MS9445
AMENDMENT 1
8 JULY 2003

MILITARY STANDARD

BOLT, MACHINE - STEEL AMS 6304, DIFFUSED NICKEL-CADMIUM PLATED, HEXAGON HEAD, DRILLED, .500-20 UNJF-3A

This amendment forms a part of MS9445, dated 21 December 1962, and is approved for use by all Departments and Agencies of the Department of Defense.

Sheet 1

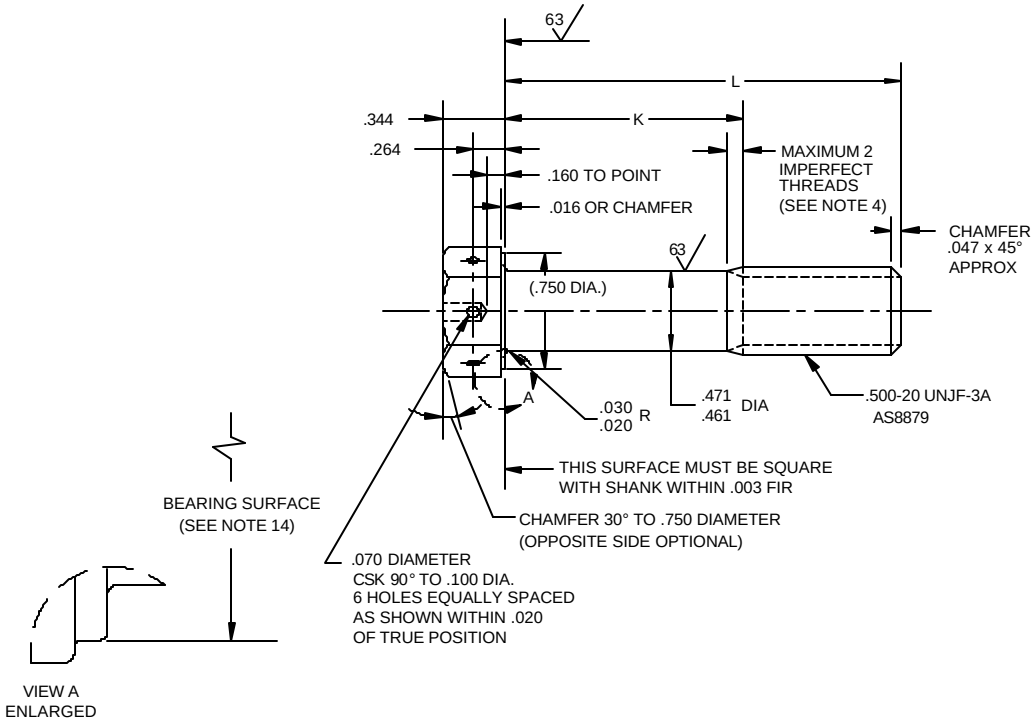
In drawing: Replace front view with this drawing and add View A.
